HCCSC Horace Mann Elementary HVAC Replacement

Project # 2025.0014

9-28-2026

ADDENDUM NO. 01

TITLE
REFLECTED CEILING PLAN - UNIT D

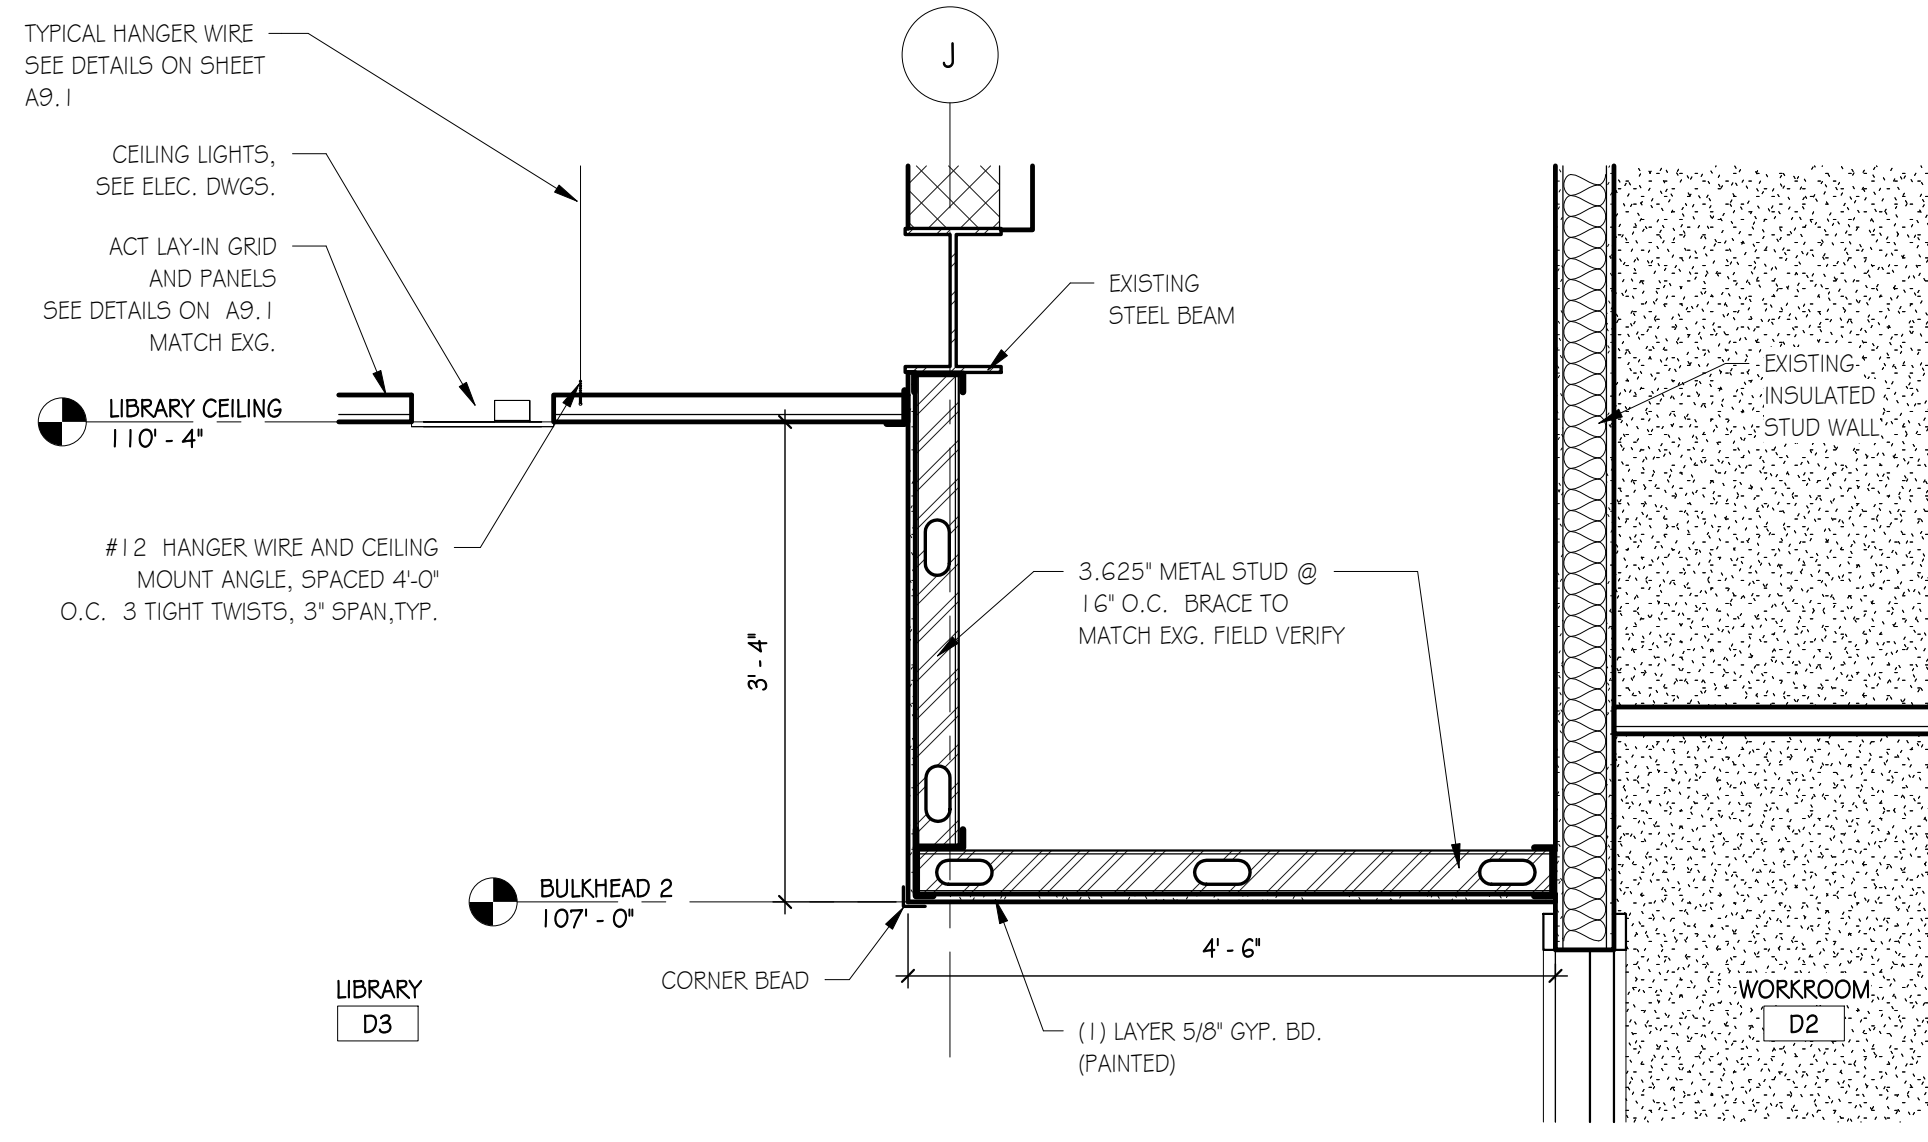
Item: A-1.5
Location: Drawings
Description: Replace existing drawing sheet A9.4 Reflected Ceiling Plan – Unit D, dated 9-21-2026, with Revised drawing sheet A9.4 Reflected Ceiling Plan-Unit D dated 9-28-2026.
Changes: **Revised orientation of removed ceiling panels in Classrooms**

DATE	PROJECT
09/21/2026	2025.0014
TITLE	FIRST FLOOR MECHANICAL DEMOLITION PLAN - UNIT B

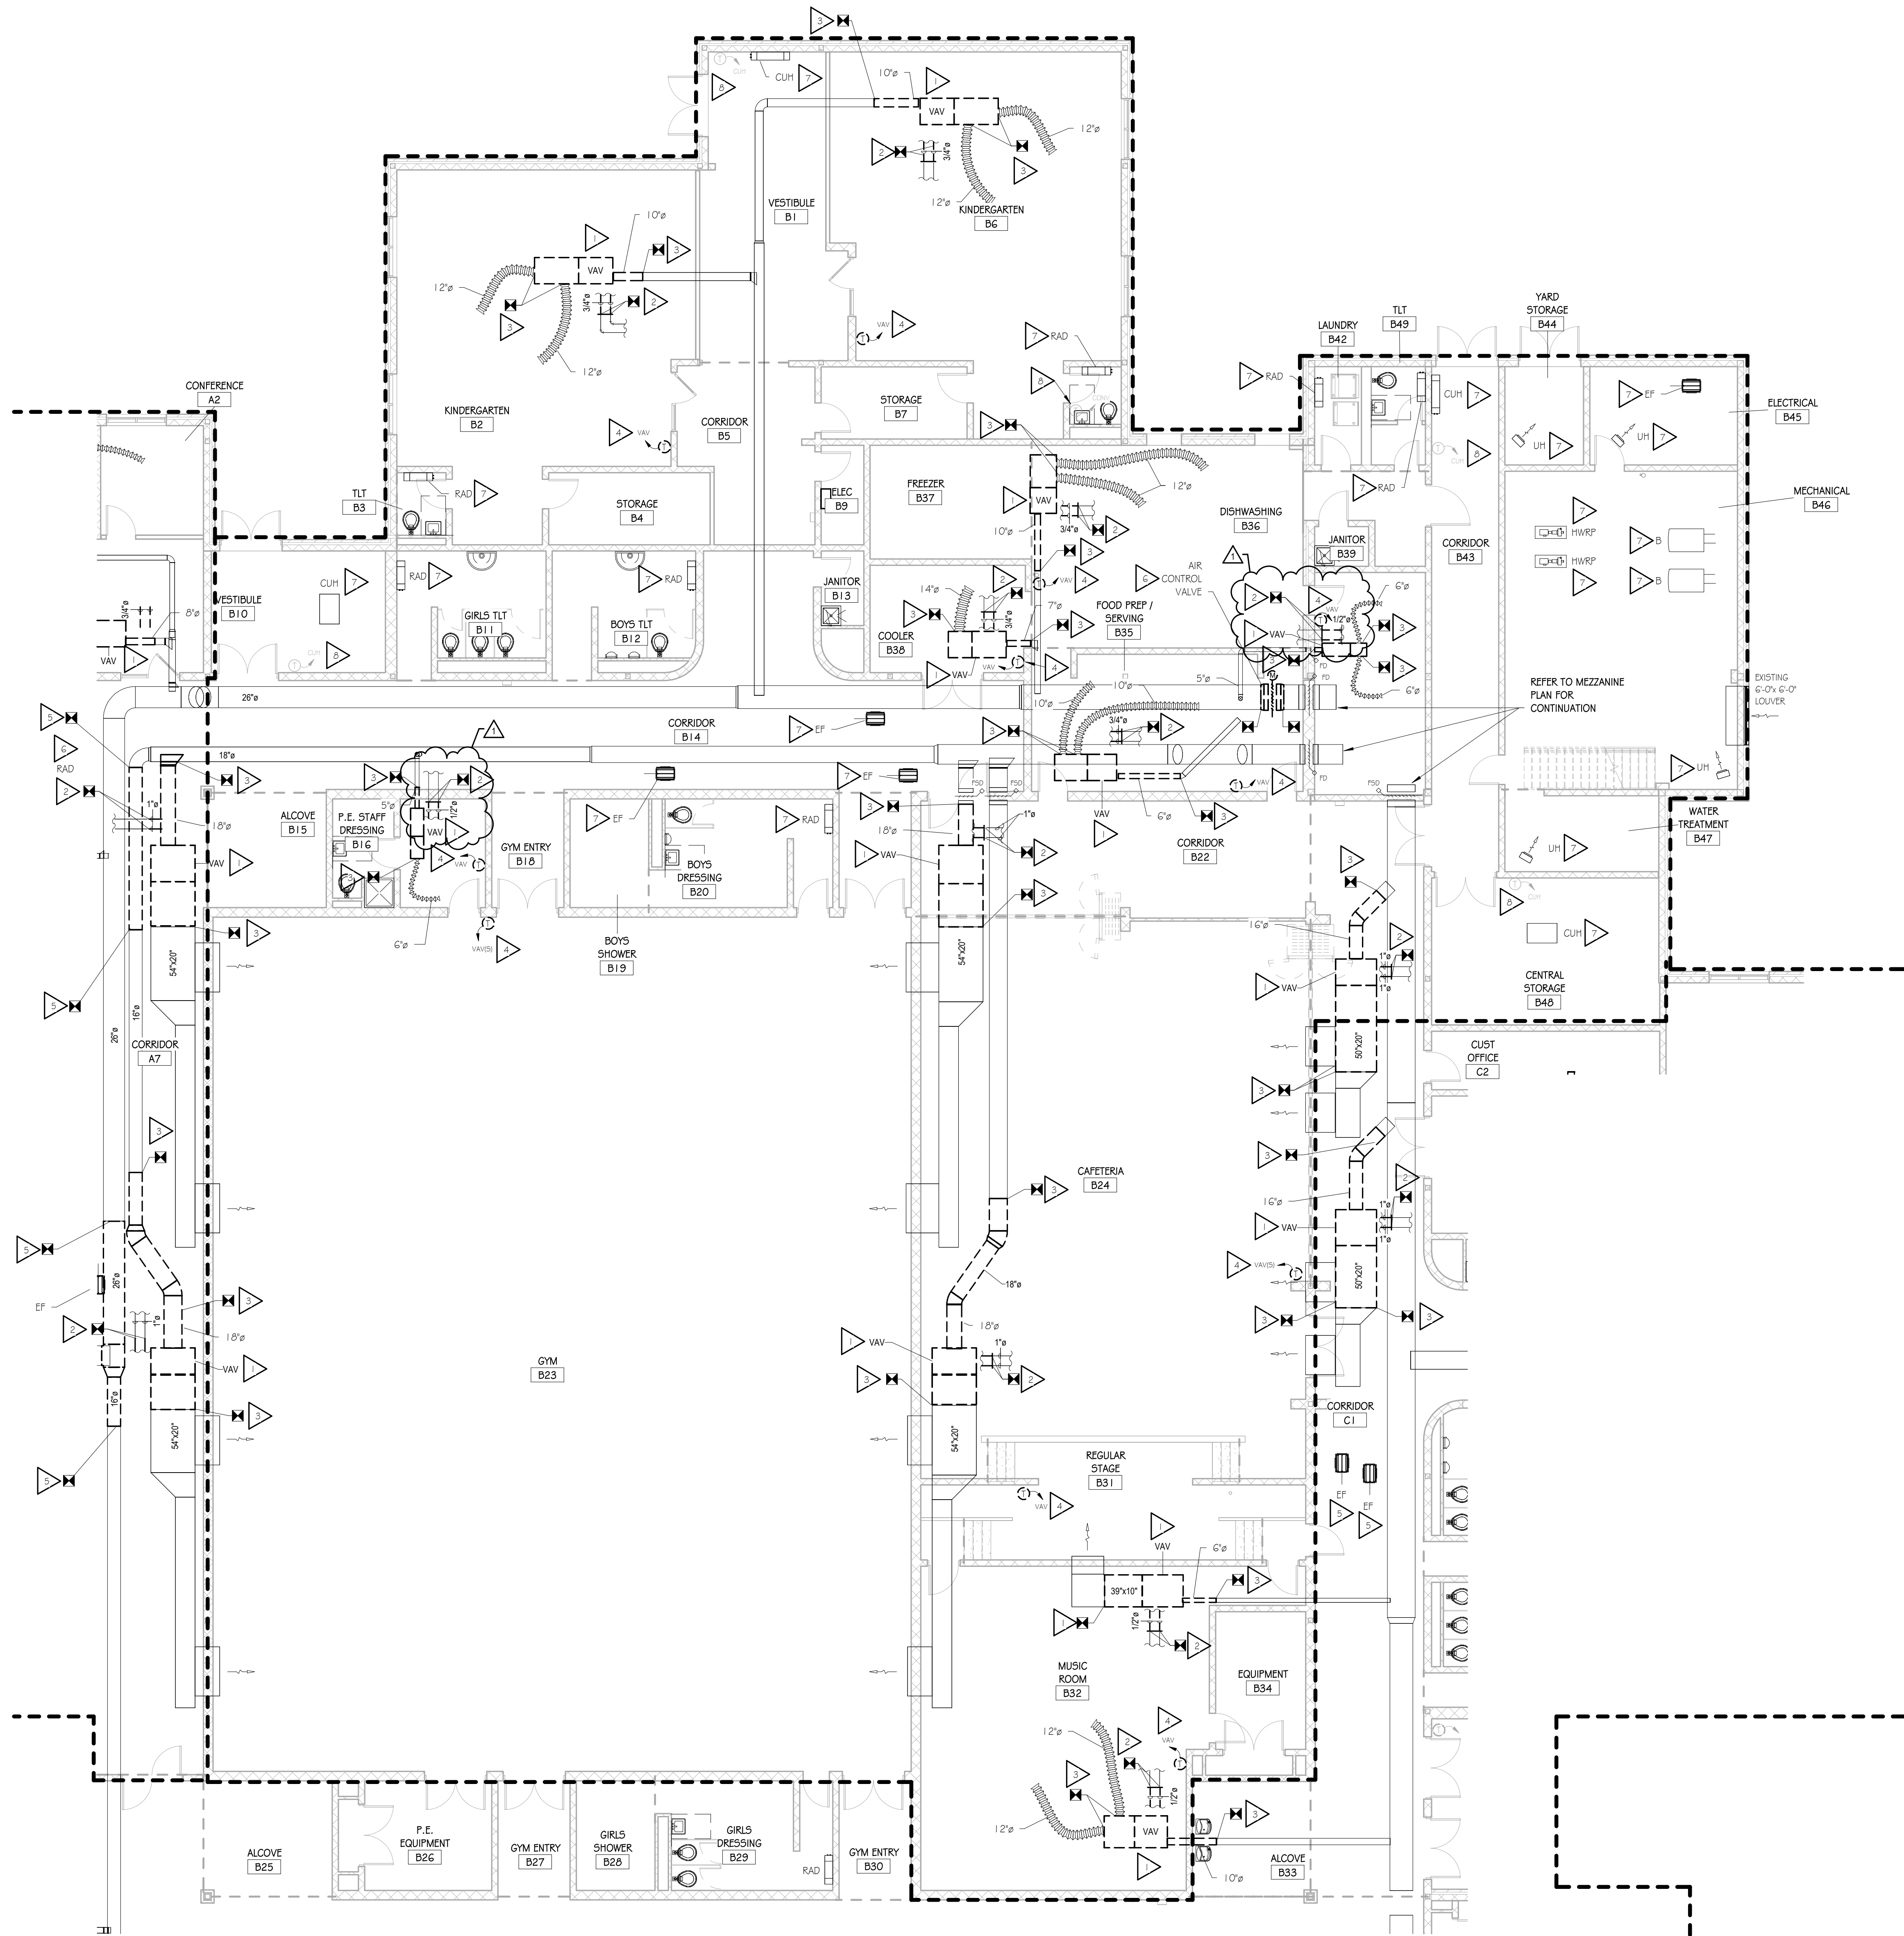
Item: A-1.7
Location: Drawings
Description: Replace existing drawing sheet MD1-1B First Floor Mechanical Demolition Plan – Unit B, dated 9-21-2026, with Revised drawing sheet MD1-1B First Floor Mechanical Demolition Plan – Unit B dated 9-28-2026.
Changes: **Select VAVs that don't have fans: add piping information. Show the pipe routing to VAVs and demolition for reconnection.**

TITLE
FIRST FLOOR MECHANICAL DEMOLITION PLAN - UNIT C

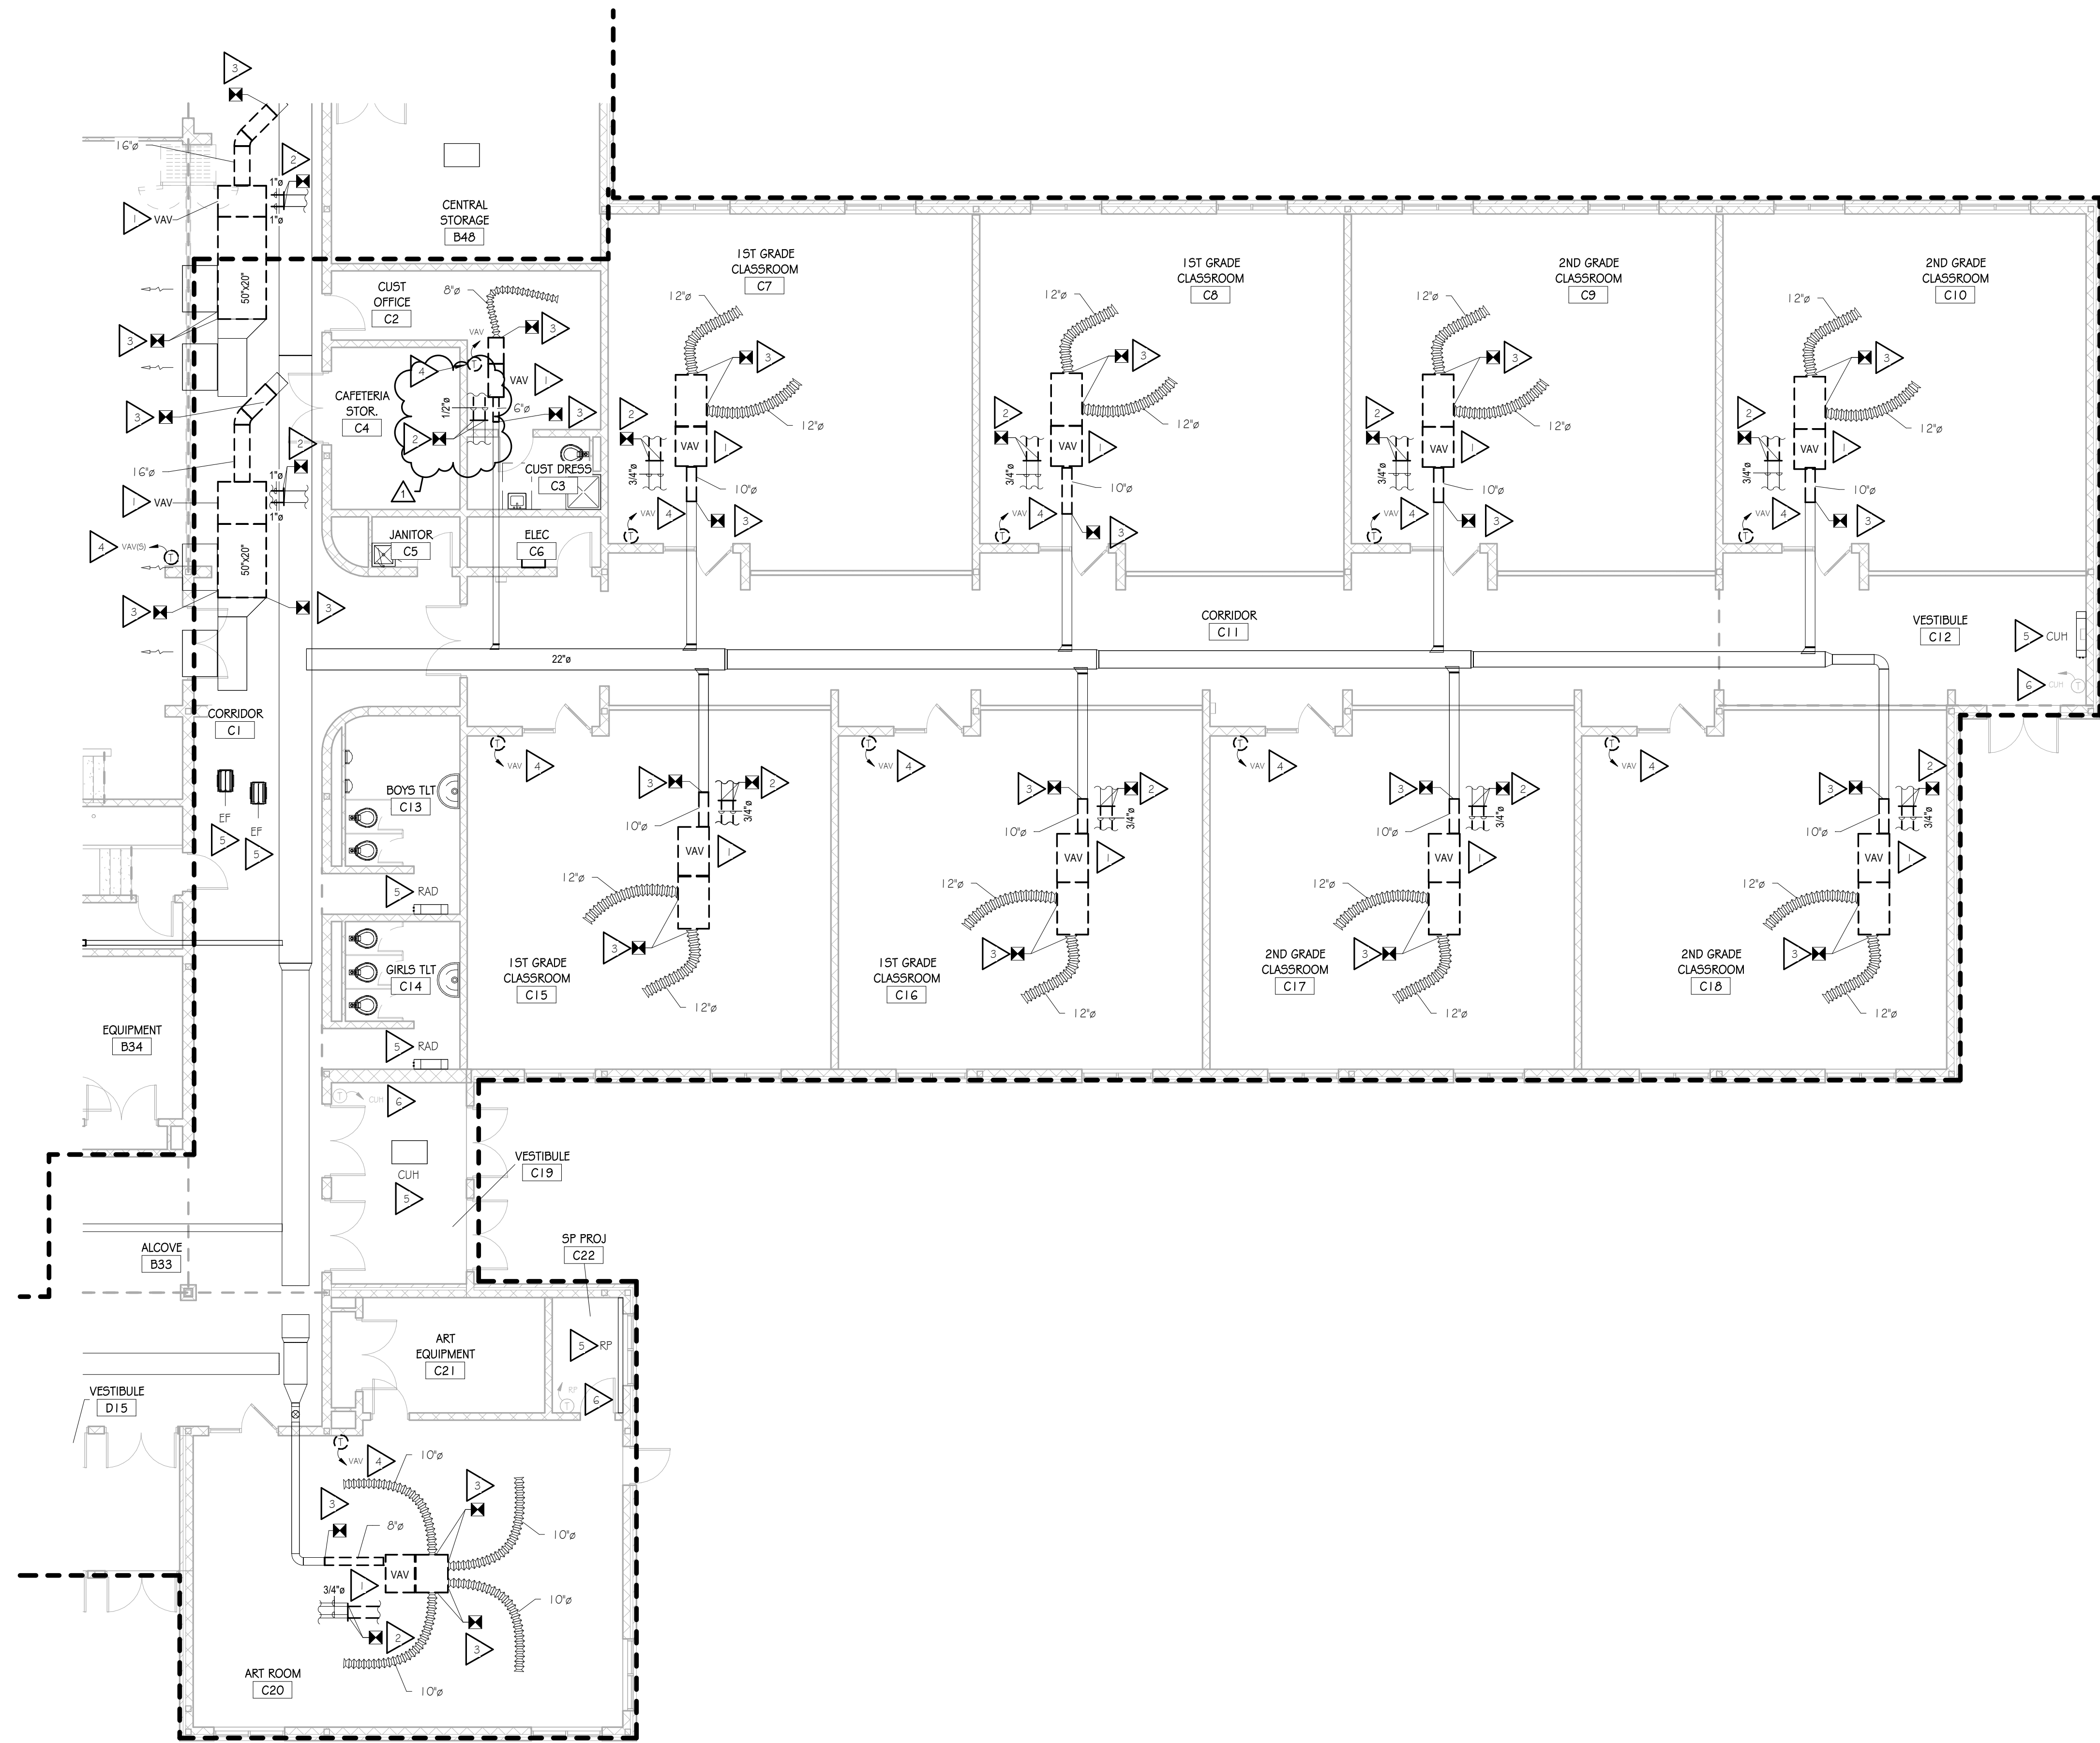
Item: A-1.8
Location: Drawings
Description: Replace existing drawing sheet MD1-1C First Floor Mechanical Demolition Plan – Unit C, dated 9-21-2026, with Revised drawing sheet MD1-1C First Floor Mechanical Demolition Plan – Unit C dated 9-28-2026.
Changes: **Select VAVs that don't have fans: add piping information. Show the pipe routing to VAVs and demolition for reconnection.**
